**Application - 2020/0913/P**

**Site address 21 Maresfield Gardens NW3 5SD**

The proposed outbuilding development at 21 Maresfield Gardens should be rejected on the following grounds:

Section AA

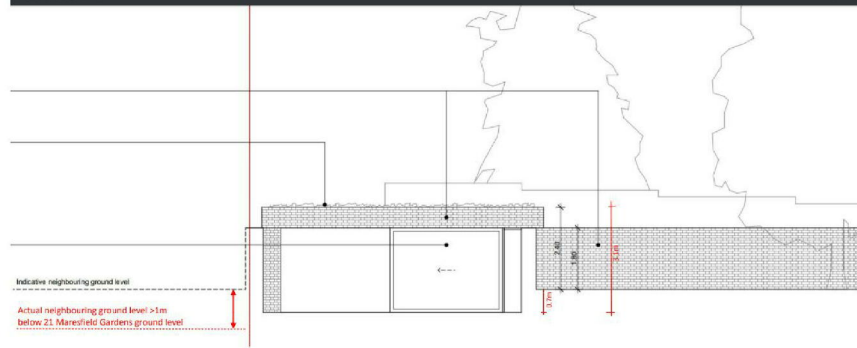
3. The application states that the height of the eaves will not exceed 2.5m metres. **This statement is incorrect.** Section AA includes only

one dimension for the building height, 2.4m, which is the proposed parapet height above the existing ground level at 21 Maresfield Gardens. However, the proposed structure abuts the rear boundary line with 8 Netherhall Gardens which has a ground level which is at least 1 metre lower than 21 Maresfield Gardens. Therefore the proposed parapet height of the western elevation, viewed from Netherhall Gardens, is over 3.4m, which exceeds the permitted development height limit. Section AA incorrectly indicates that the neighbouring garden level in Netherhall Gardens is the same as 21 Maresfield Gardens- see attached drawing.

4. Section AA shows a building height of 2.4m relative to the existing ground level. The drawing also indicates that the floor level of the proposed building will sit below the existing ground level. There are no figures provided for levels on the proposed drawing, nor any dimension for the internal floor to ceiling height. Scaling off Section AA, there is a 0.7m difference between the internal floor level and ground level, which would indicate a total building height of 3.1m (see attached drawing). The supporting document to the application states that the new building will not exceed 3m in height- this is inconsistent with the drawings. The building height indicated on Section AA is 3.1m and therefore **the proposed structure exceeds the permitted development overall height limit of 3m.**
